Bethesda Downtown Design Advisory Panel

Meeting Minutes

PROJECT: 4824 Edgemoor Lane
320200020 Sketch Plan Application

DATE: February 26, 2020

ALTERNATE MASSING OPTION

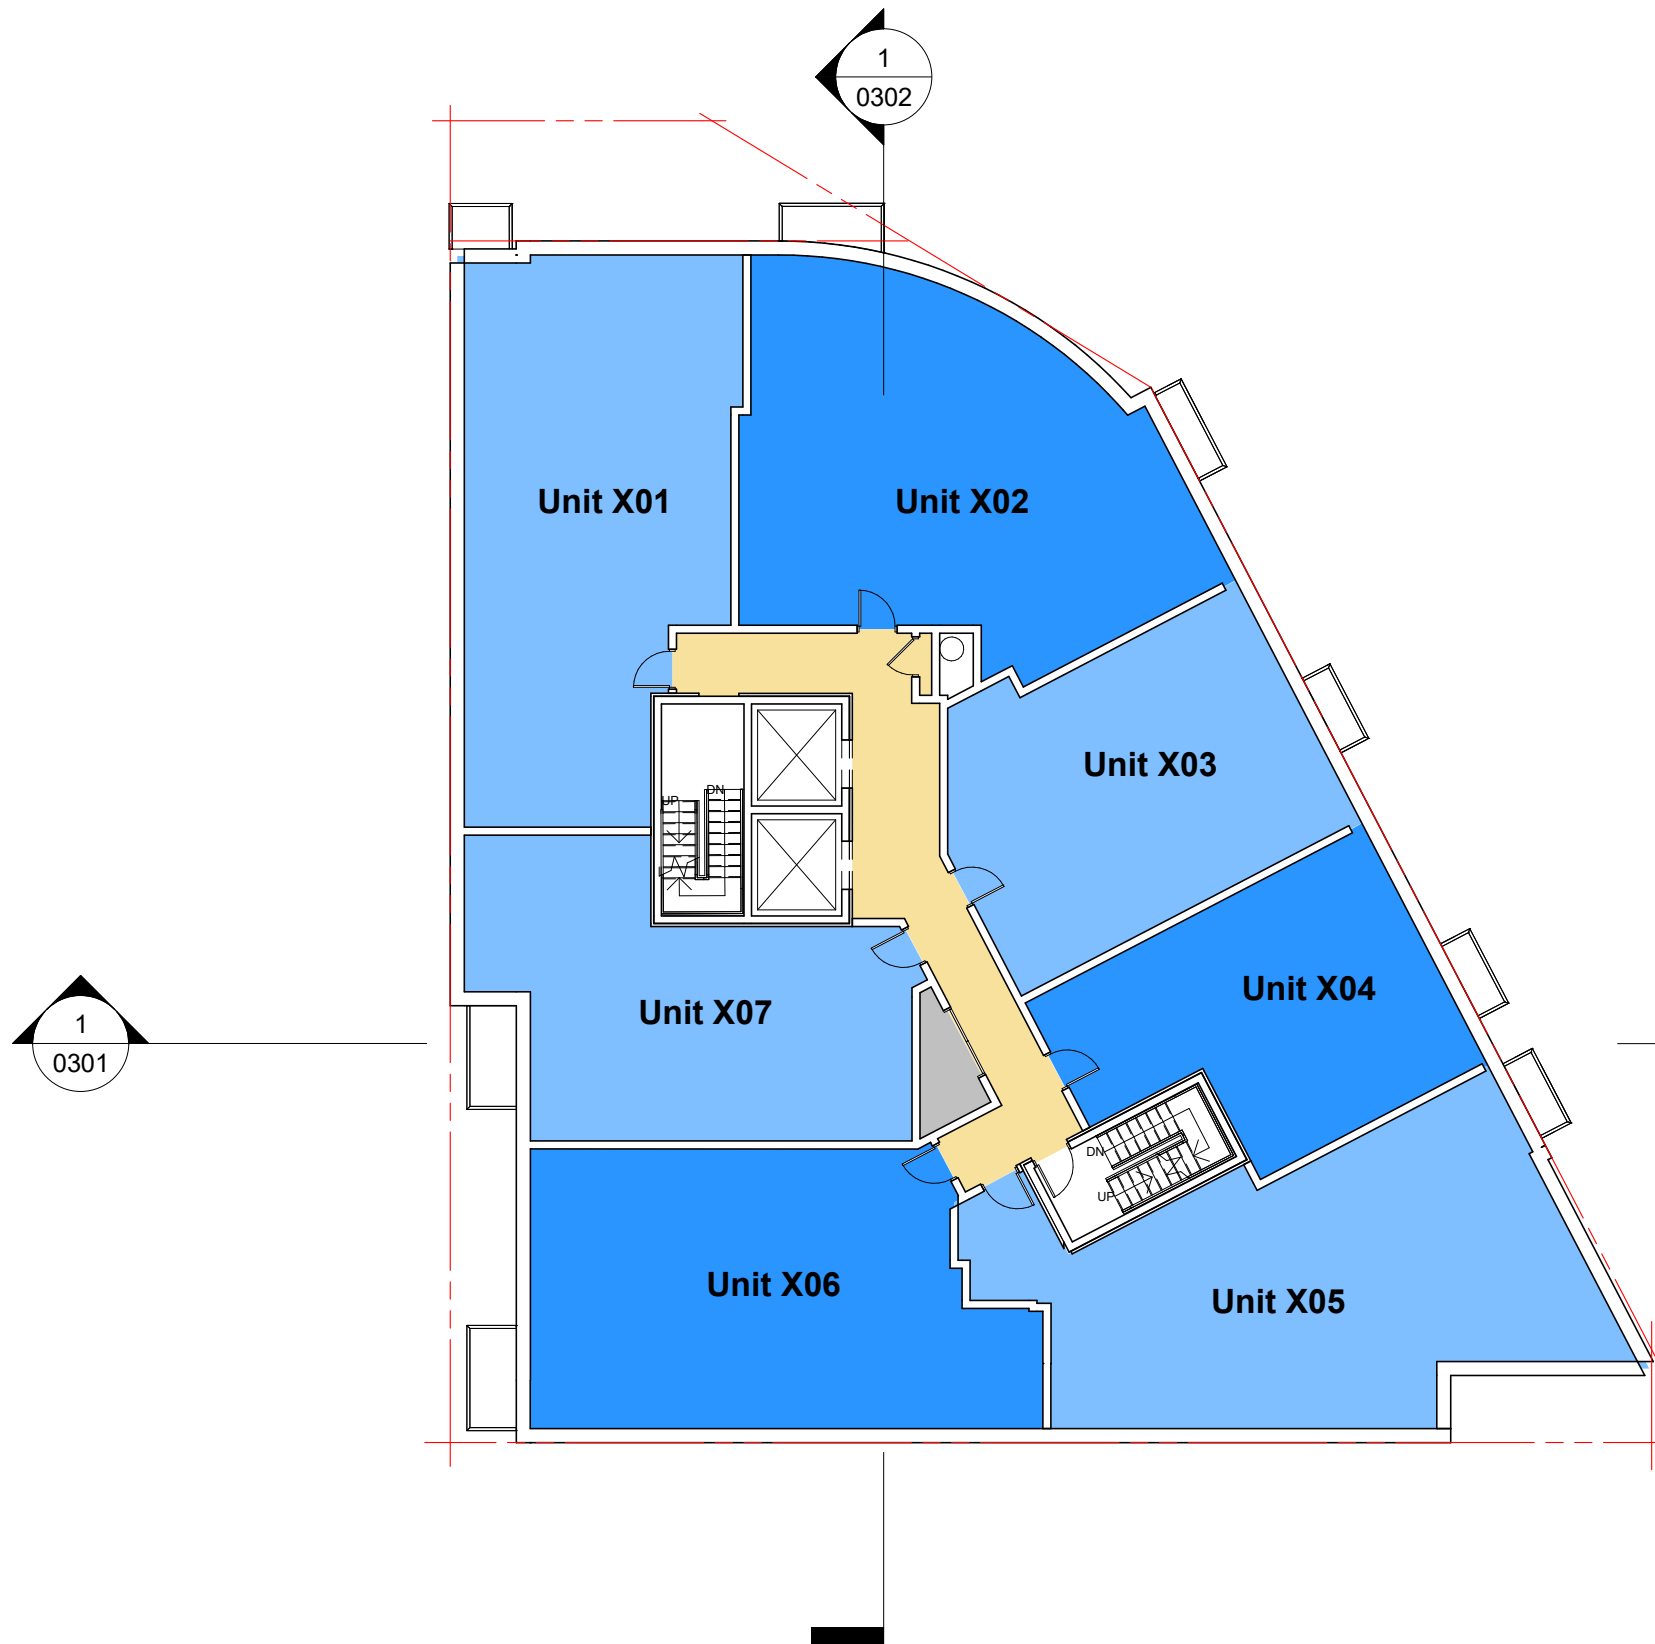
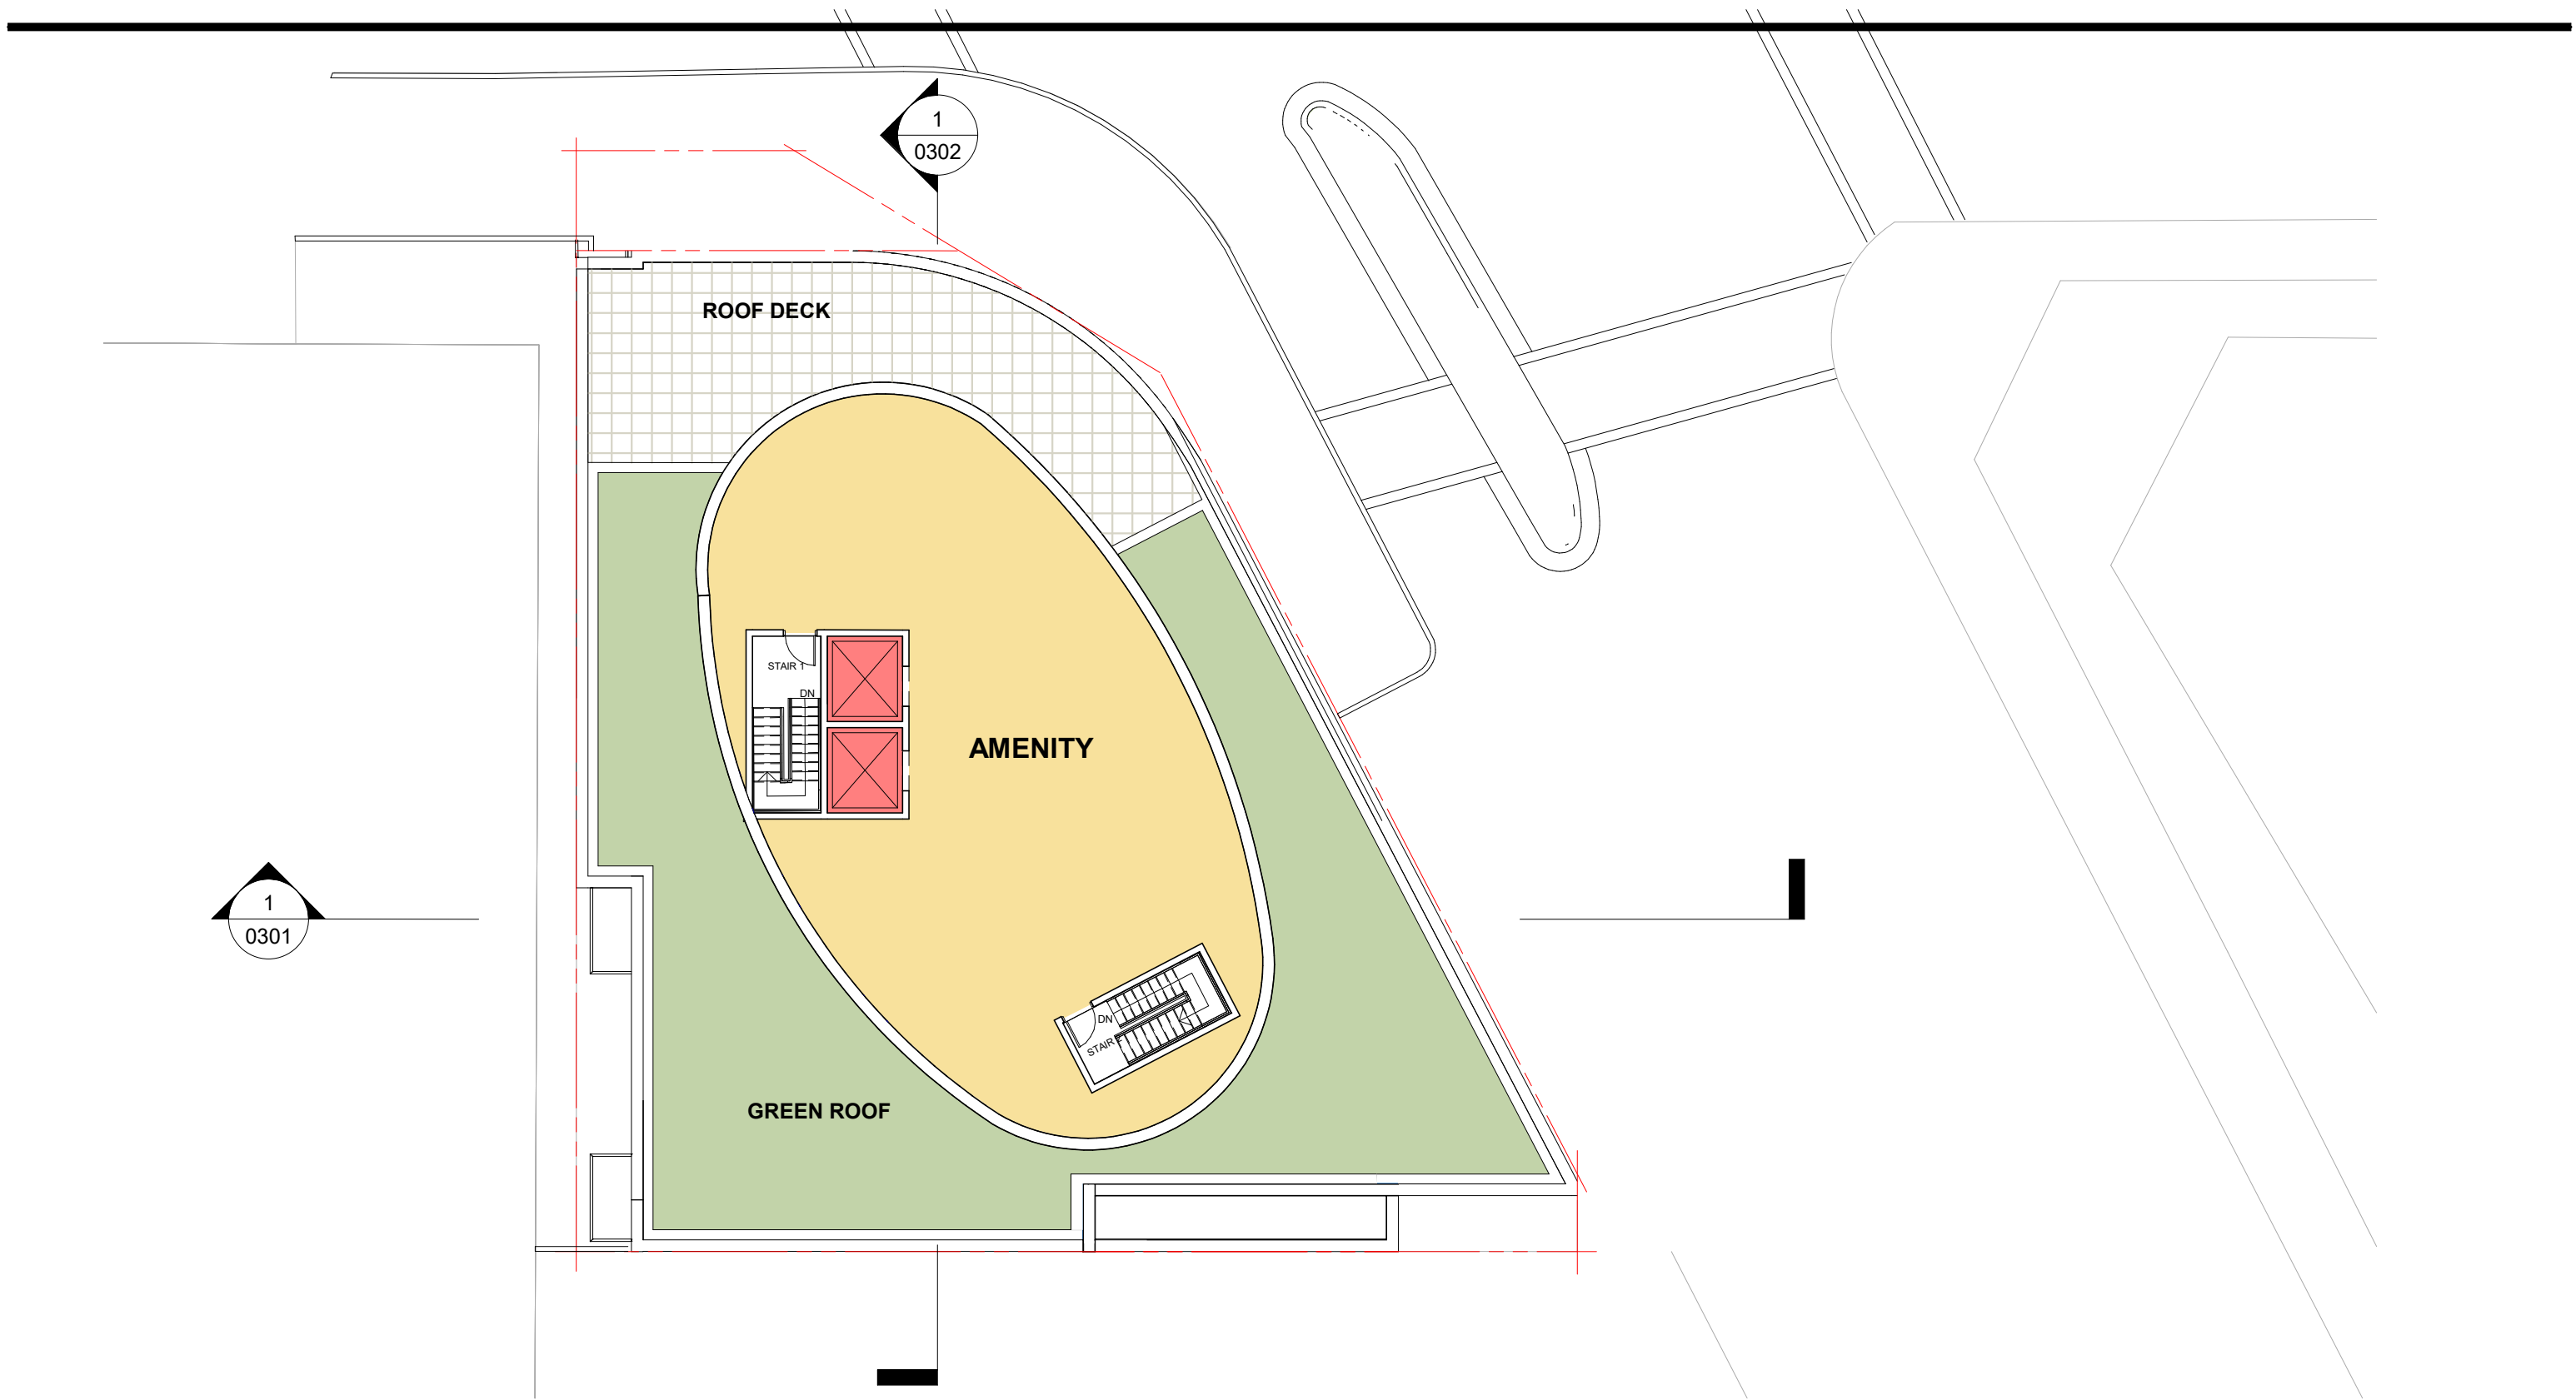
- For the south façade, do you have a preference between the two massings presented?
 - *Applicant Response: The first massing with the smaller amount of setback would be the preference. Given the steel structural type, it would be easier to construct.*

- Explore methods to increase tower separation above the base (4 stories) to achieve a minimum separation of 30' and an average of 40'.
